FIELD CHANGE SHEET

FED ROAD REG. NO.	STATE	CONTRACT NO.	SHEET NO.	TOTAL SHEETS
1	N.Y.	D259317	25F1	61
SH 5243, SANITARIA SPRINGS - HARPURVILLE				
NYS ROUTE 7				
TOWN OF COLESVILLE				
BROOME COUNTY				
P.I.N. 980434		B.I.N. 1003760

NOTES:
 SHEET 25 F1 VOIDS ORIGINAL SHEET 25
 THIS FIELD CHANGE SHEET PEDESTAL REMOVAL AND NOTE CHANGE

NYS ROUTE 7/BELDEN BROOK

REMOVAL AND EXCAVATION DETAILS

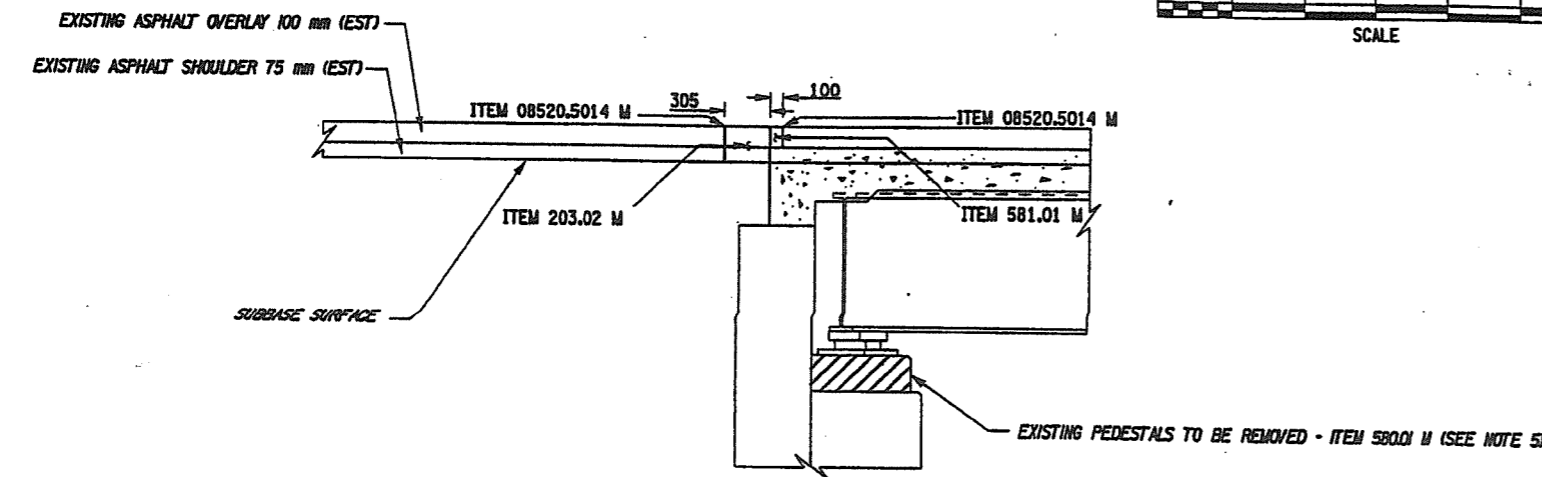
5. DUE TO THE DIFFERENCE IN HEIGHT BETWEEN THE EXISTING STEEL ROCKER BEARINGS AND THE NEW TYPE EB ELASTOMERIC BEARINGS THE HEIGHT OF THE NEW PEDESTALS WILL INCREASE. IT IS THE INTENT OF THIS PROJECT TO MAINTAIN THE EXISTING ROAD PROFILE. IT IS THE CONTRACTOR'S RESPONSIBILITY TO ENSURE THAT AFTER THE BEARING AND PEDESTAL REPLACEMENT IS COMPLETE THAT THE ORIGINAL ROADWAY PROFILE IS MAINTAINED.

PEDESTAL RECONSTRUCTION

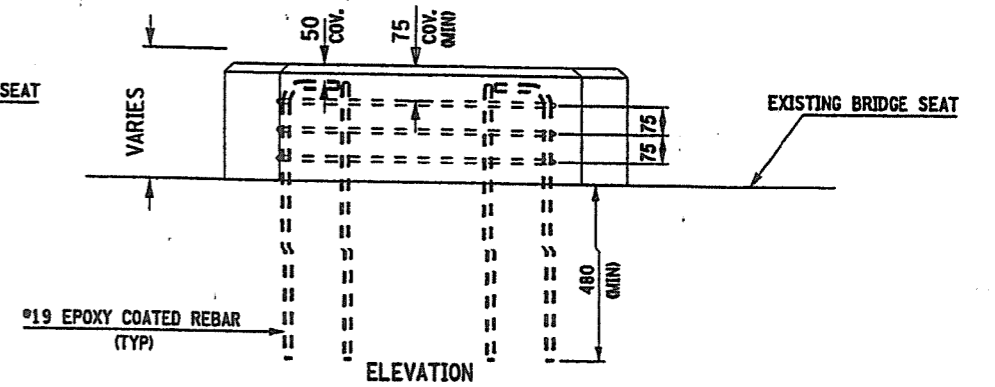
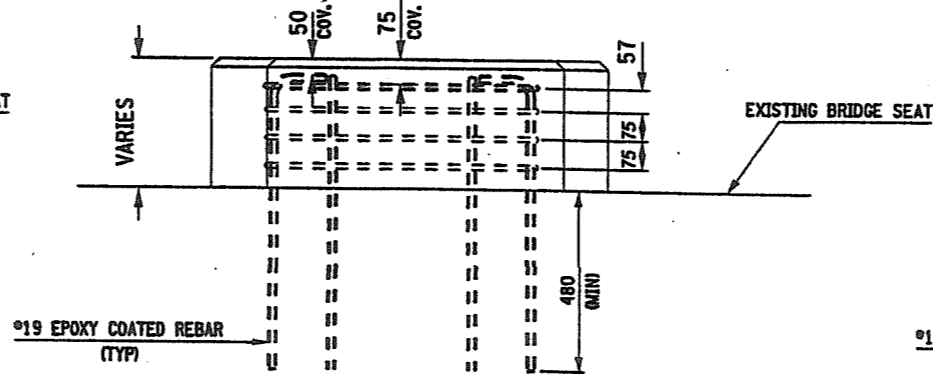
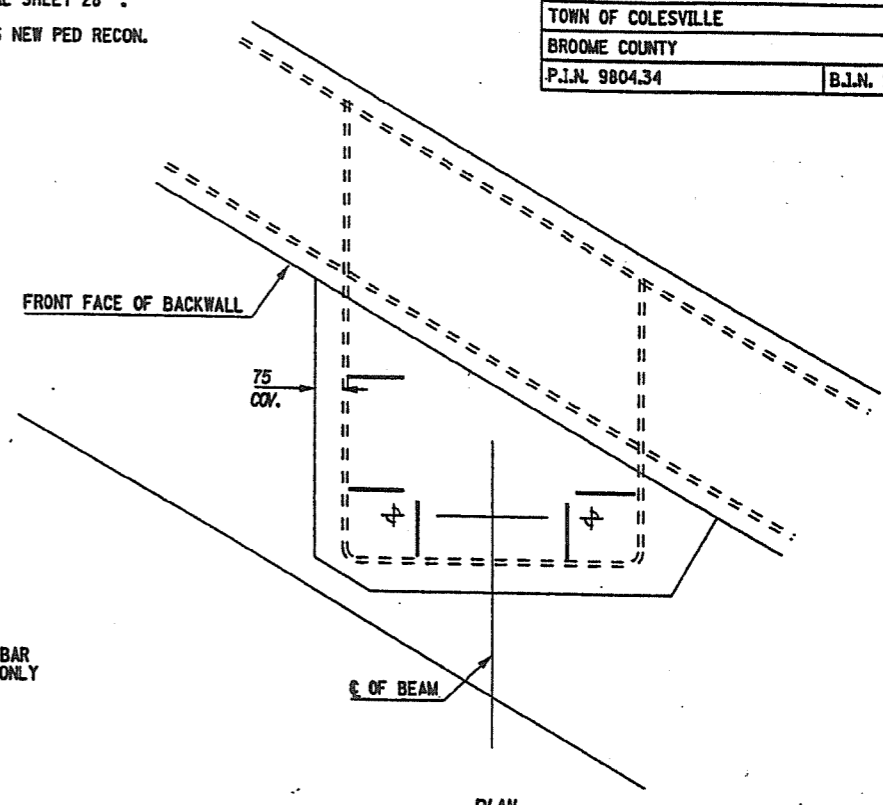
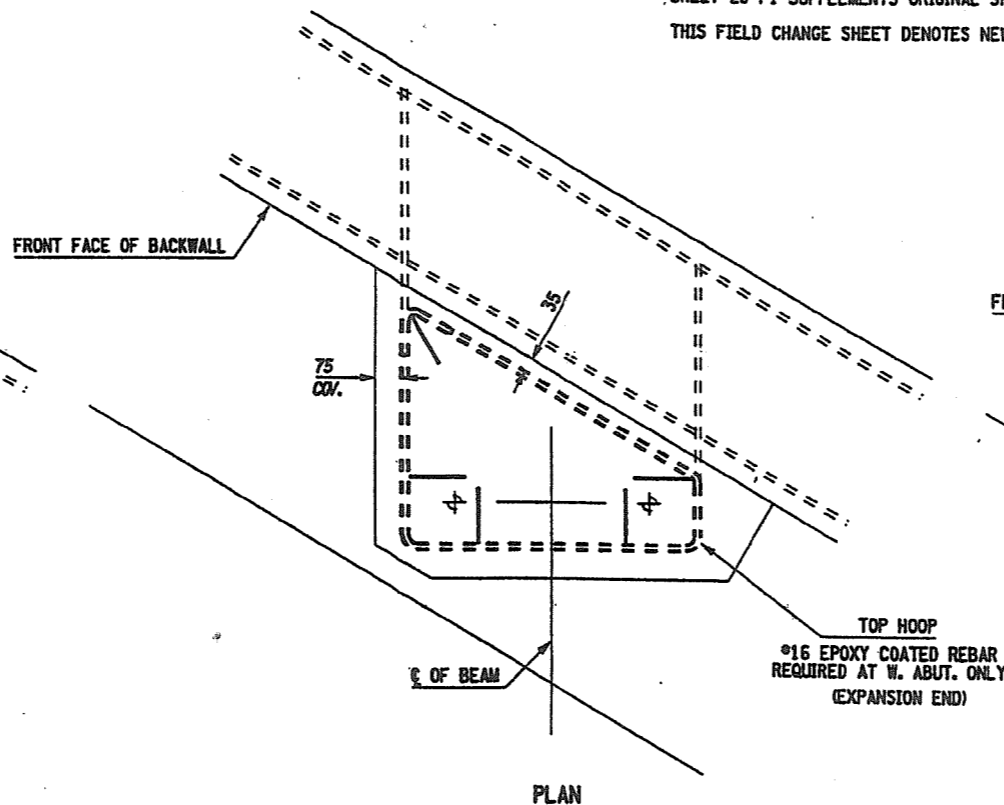
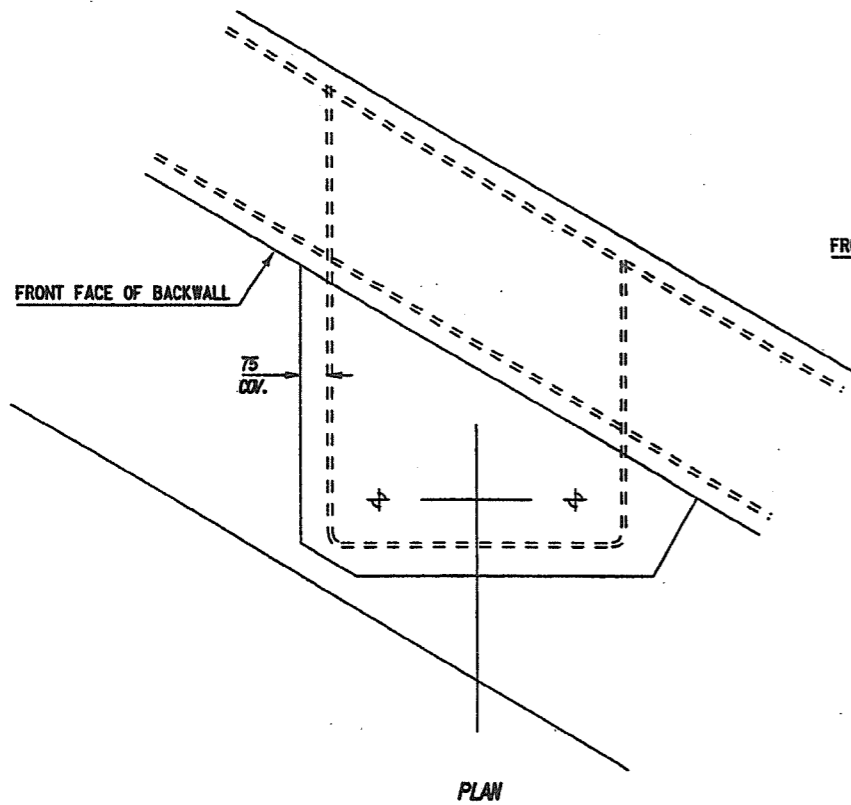
NOTES:
 SHEET 28 F1 SUPPLEMENTS ORIGINAL SHEET 28 .
 THIS FIELD CHANGE SHEET DENOTES NEW PED RECON.

TOP HOOP
 #16 EPOXY COATED REBAR
 REQUIRED AT W. ABUT. ONLY
 (EXPANSION END)

EXISTING PEDESTAL REBAR

PROPOSED PEDESTAL REBAR

SIGNATURE _____ DATE _____
 NYS ROUTE 7/BELDEN BROOK
 JOINT RECONSTRUCTION DETAILS

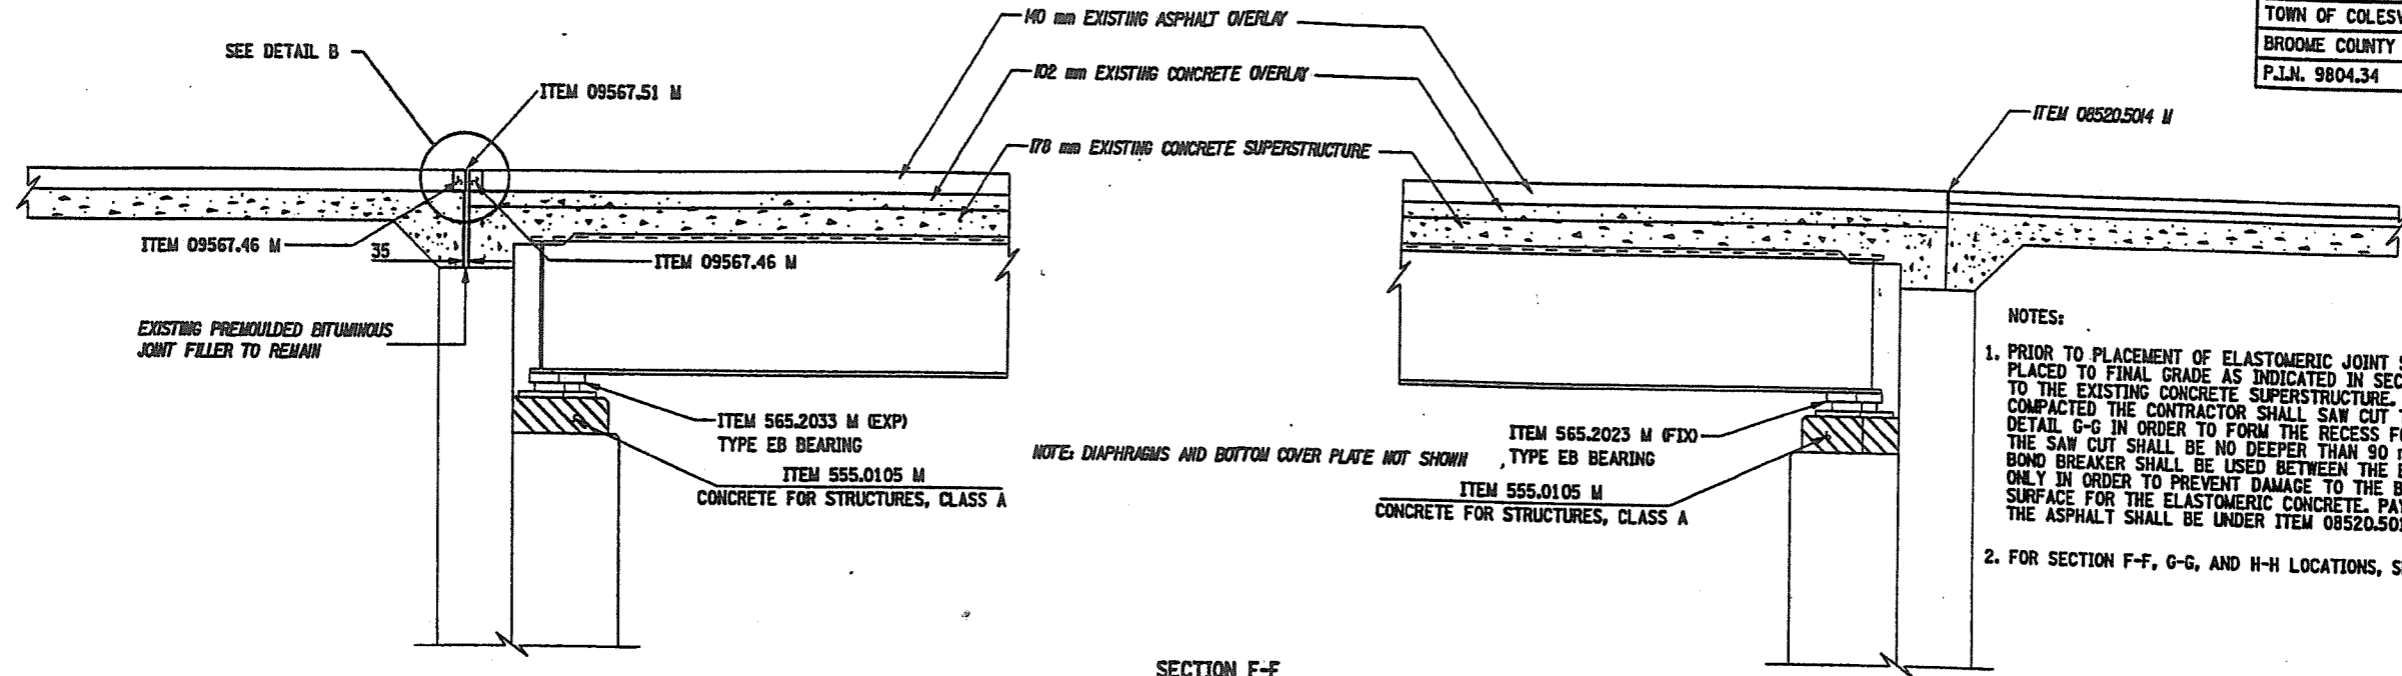
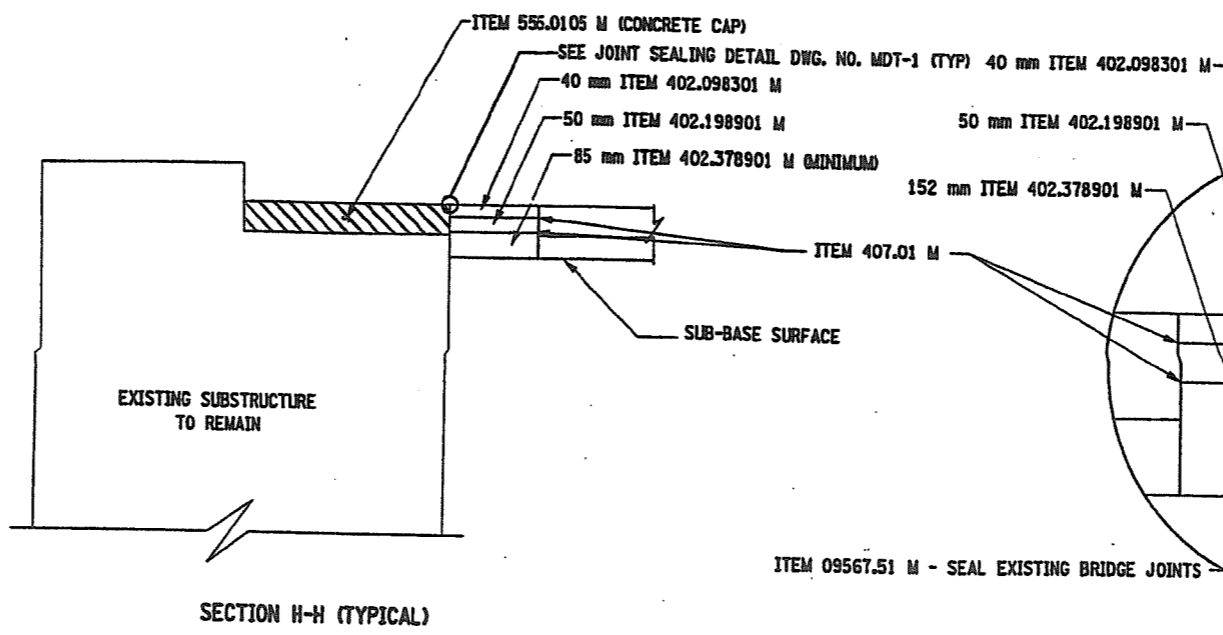
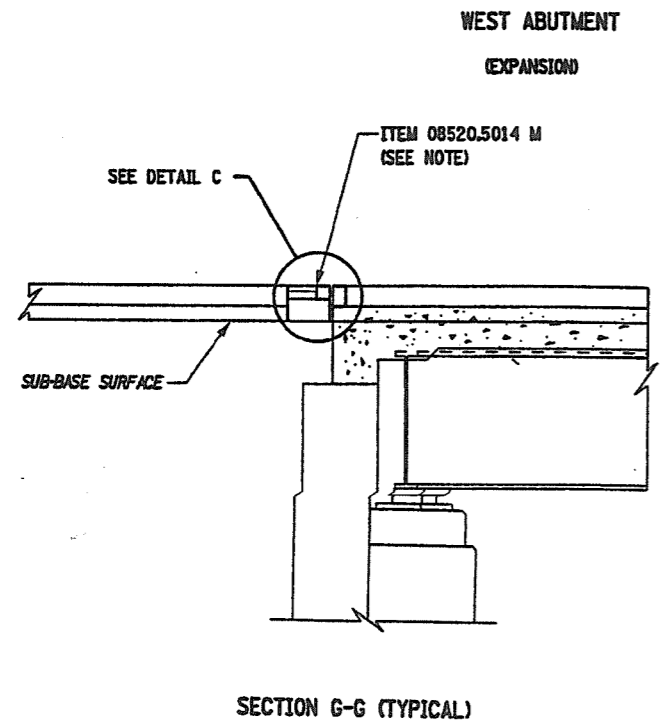
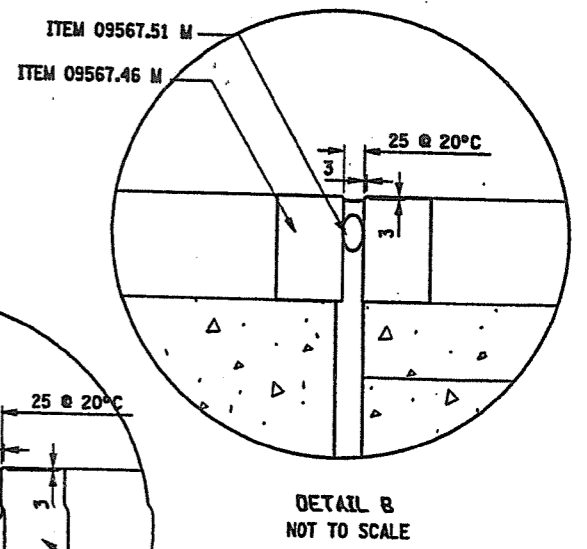
NOTES:
 SHEET 29 F1 VOIDS ORIGINAL SHEET 29 .
 THIS FIELD CHANGE SHEET DENOTES PEDESTAL REPLACEMENT ITEM

EXPANSION BEARING DETAILS

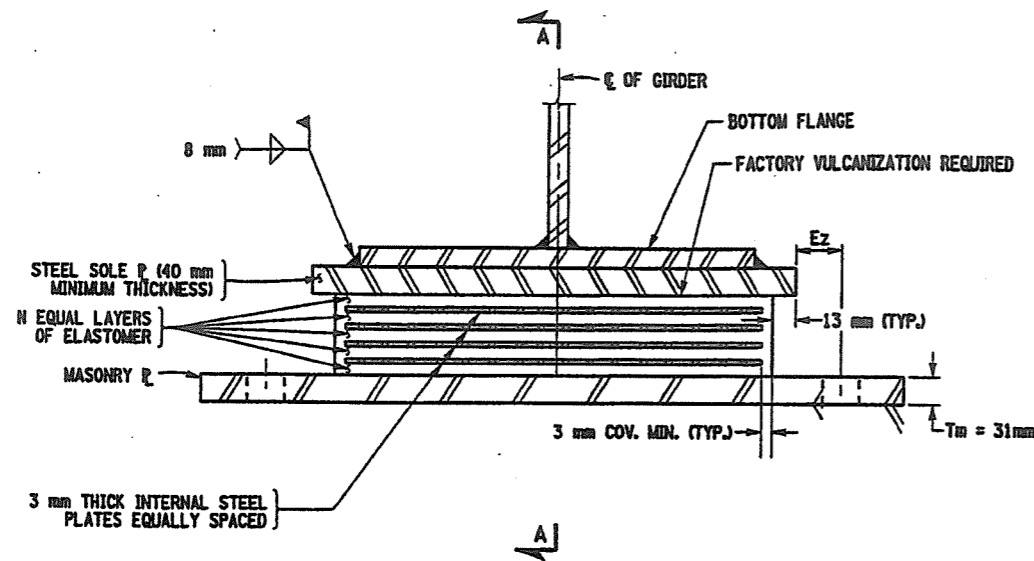
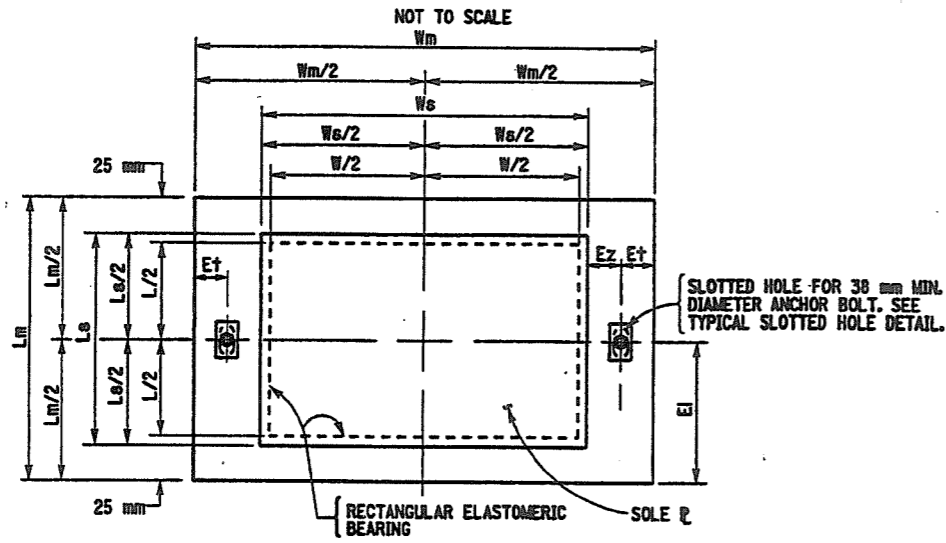
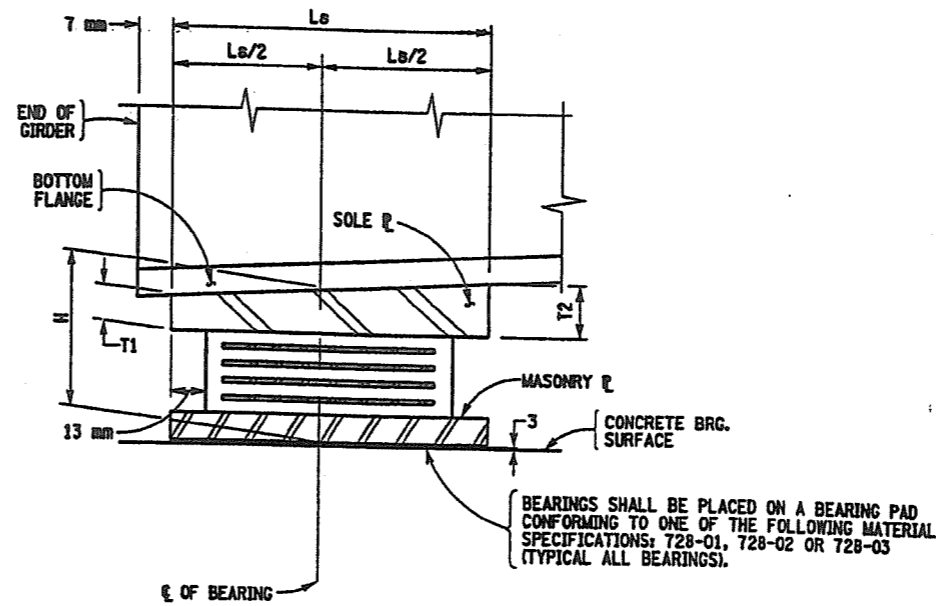
NOTES:
 SHEET 33 F1 VOIDS ORIGINAL SHEET 33 .
 THIS FIELD CHANGE SHEET DENOTES SHIM PLATE REMOVAL

FIXED BEARING DETAILS

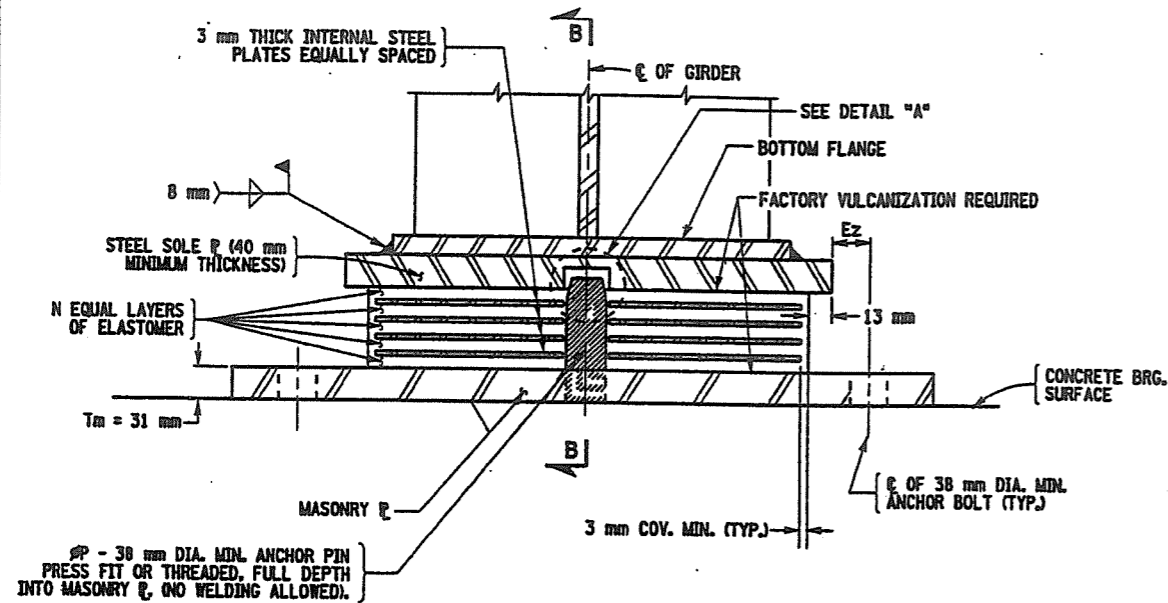
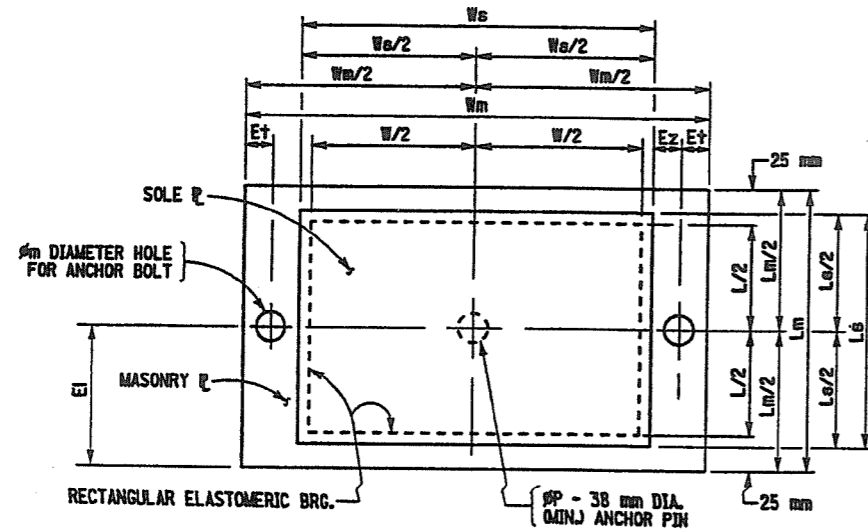
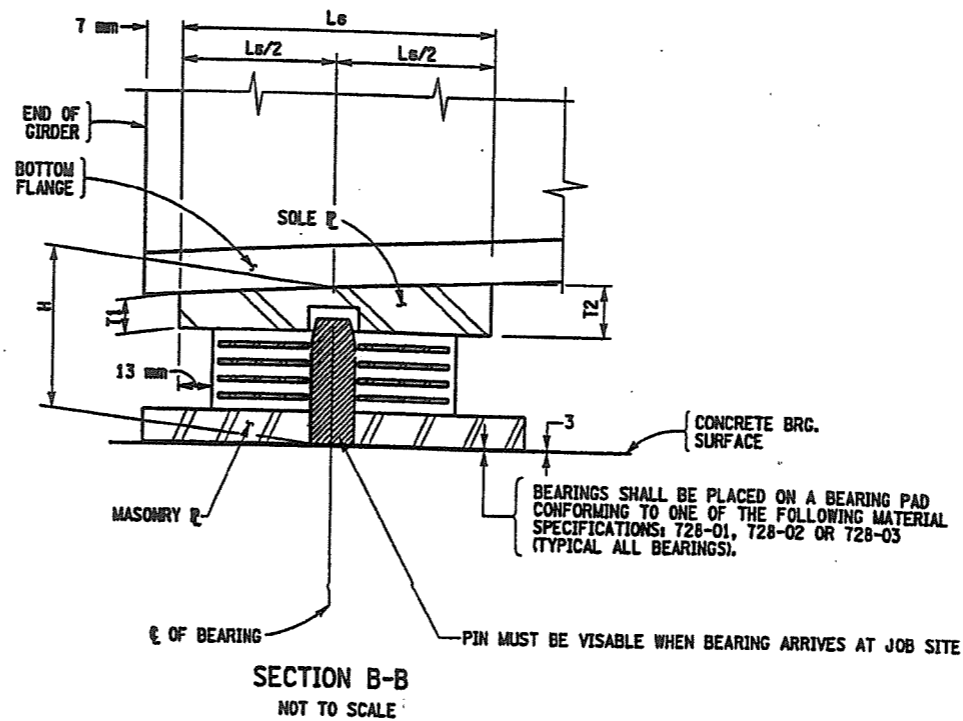
NOTES:
SHEET 34 F1 VOIDS ORIGINAL SHEET 34
THIS FIELD CHANGE SHEET DENOTES SHIM PLATE REMOVAL
